RE: **Kidz Academy**
McMahon and Fineland NW
Grading Plan and Drainage Report
Engineer's Stamp Date 2/20/18 (File: A11D016)

RE: **Kidz Academy
McMahon and Fineland NW
Grading Plan and Drainage Report
Engineer's Stamp Date 2/12/18 (File: A11D016)**

REVISED
DRAINAGE REPORT

KIDZ ACADEMY
Parcel A1A and A1B Fineland Subdivision
Albuquerque, New Mexico

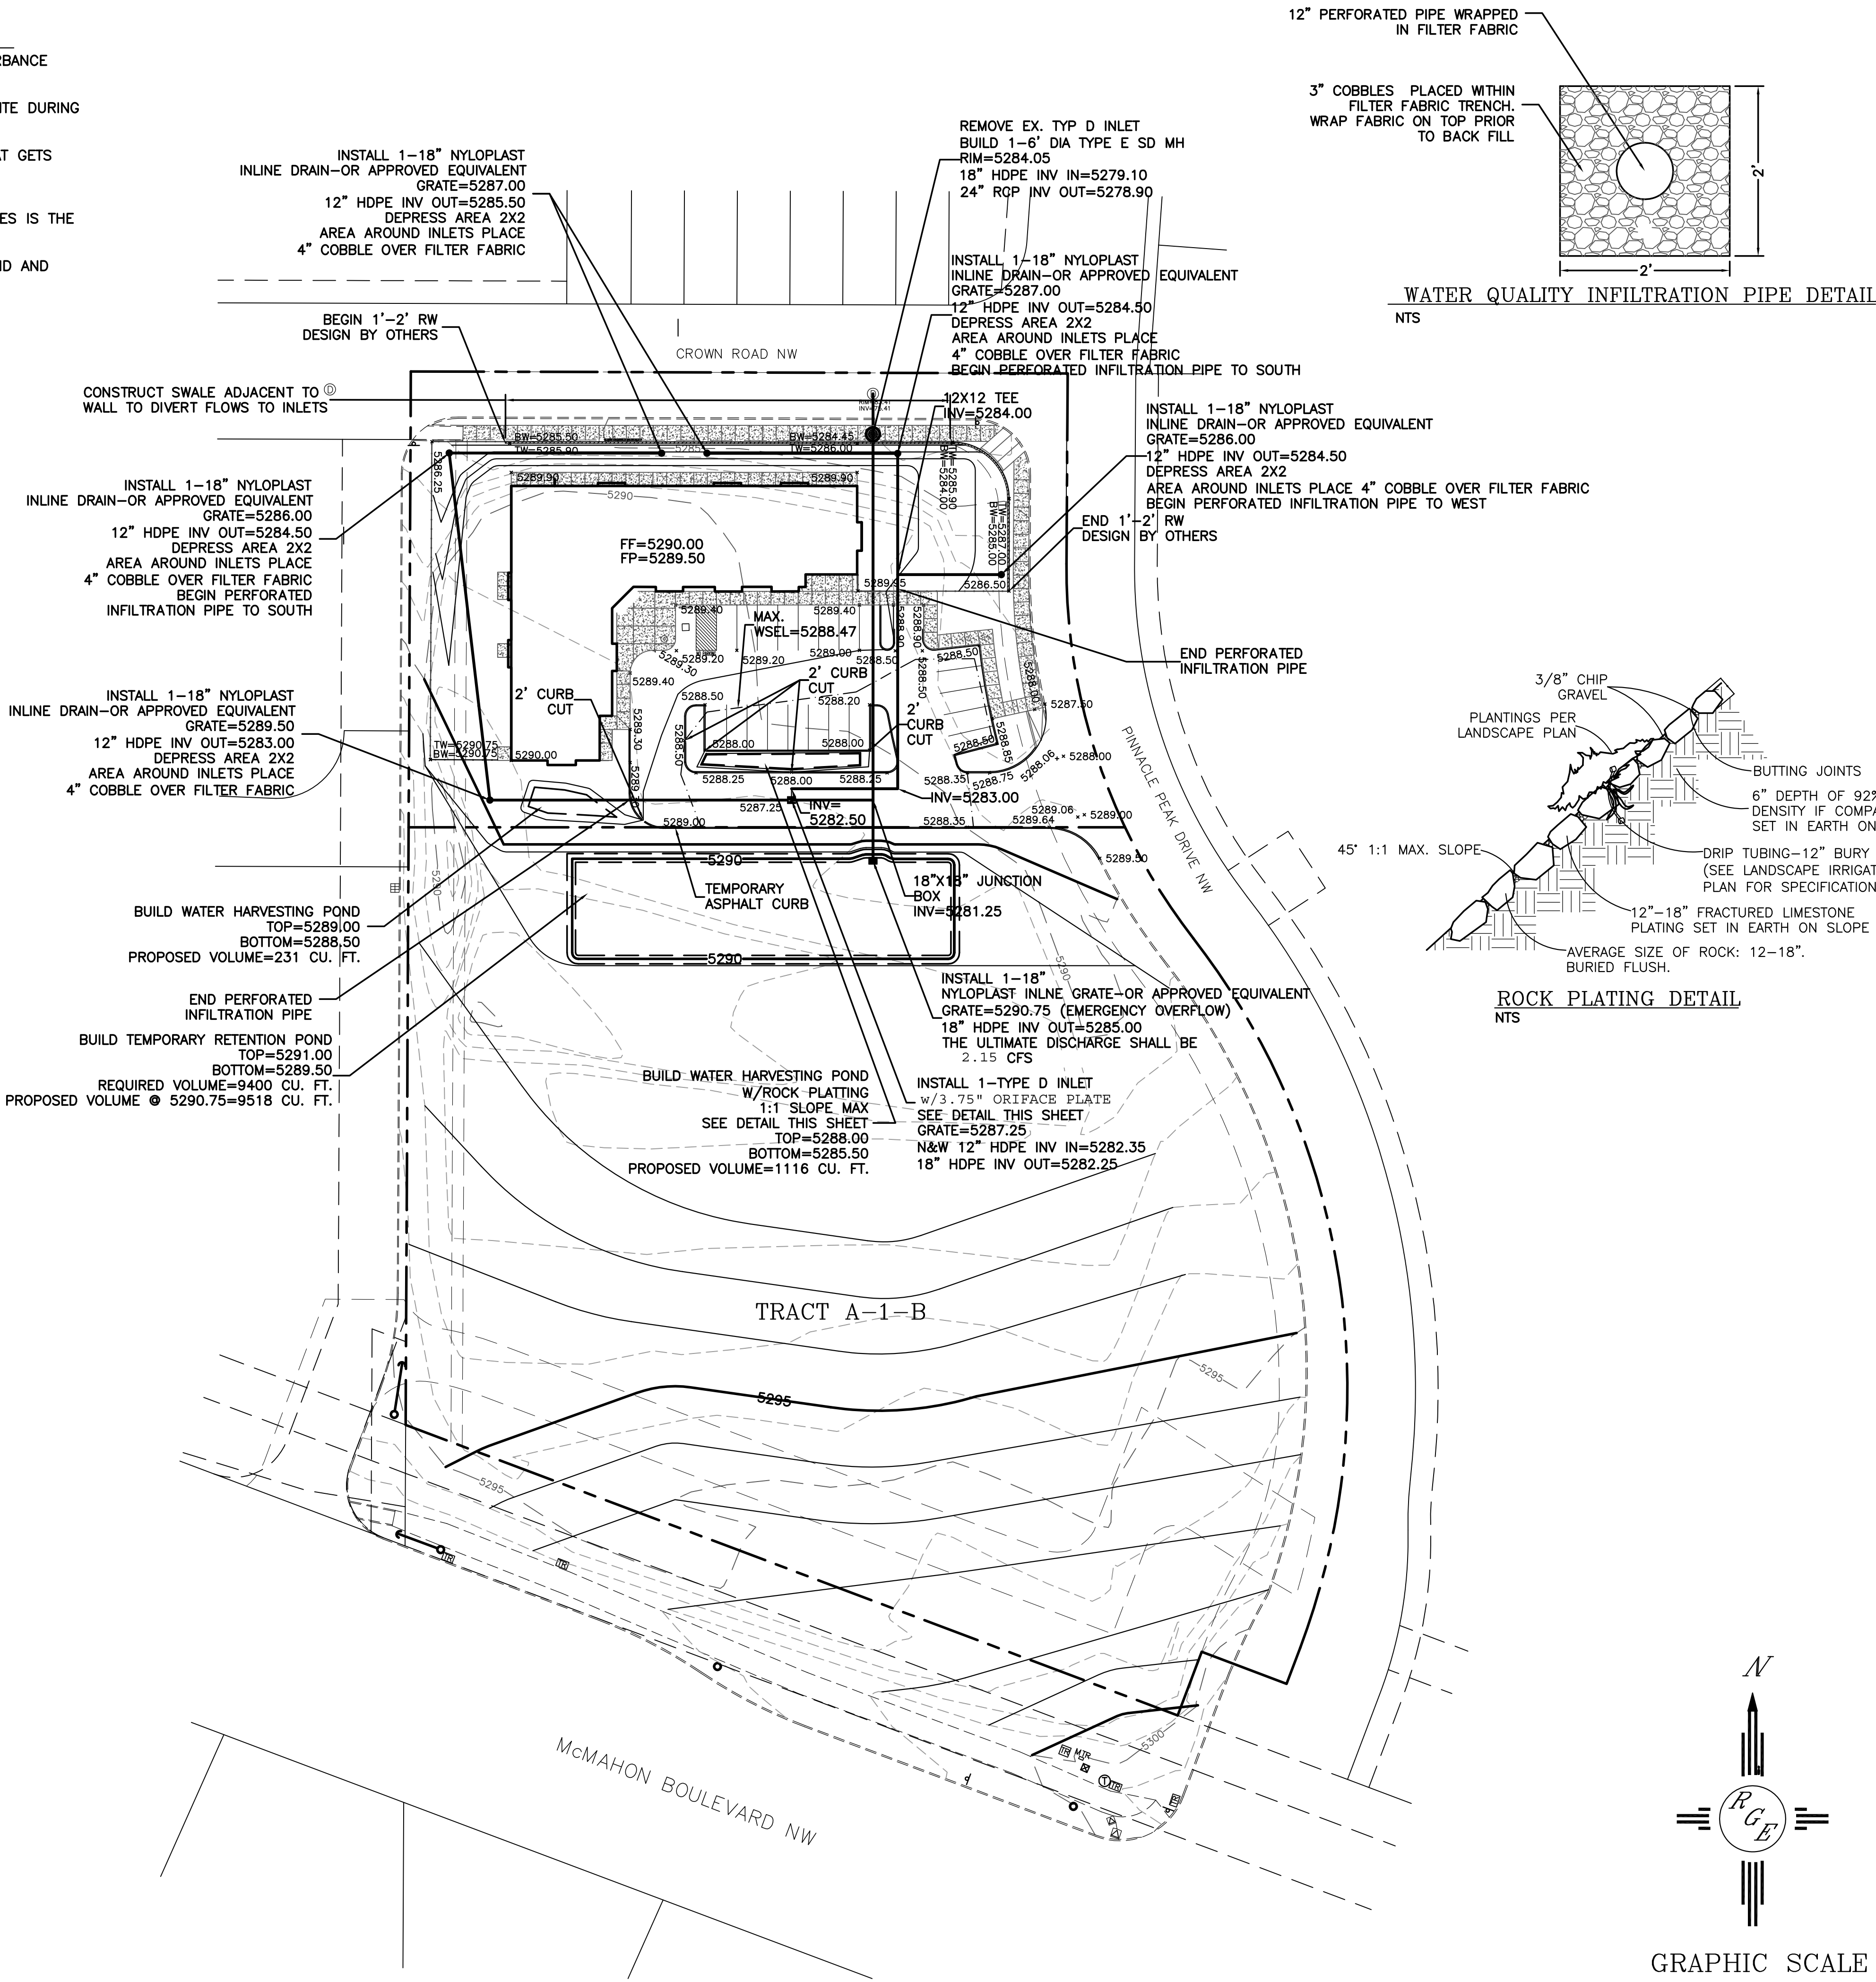
4. The AHYMO model shows the pond as having outflows beginning at elevation 85.52', but on the plan, the inlet grate elevation is at 87.25'. Please clarify the routing. Is this outflow from Basin A bypassing the pond and going right to the orifice plate inlet?
The outflow is the invert of the orifice at 85.50. All basins drain to inlet

5. What is the function of the storm drain w/ inline drains around the building? Previously these were used for routing the roof drains to the orifice plate/inlet near the pond, but now they seem to be just for area drains to capture runoff from Basin A. If so, they do not appear to be placed where they will intercept all flows from Basin A.
The report better explains

6. The small amount of impervious area in Basin A does not appear to be routing through any first flush pond. It appears to either free discharge onto Crown Rd or get routed through the orifice plate/inlet, but not get retained anywhere. If true payment, of Fee-in-Lieu will be required for this impervious area.
INFILTRATION GALLERY PROVIDED FOR BASIN A
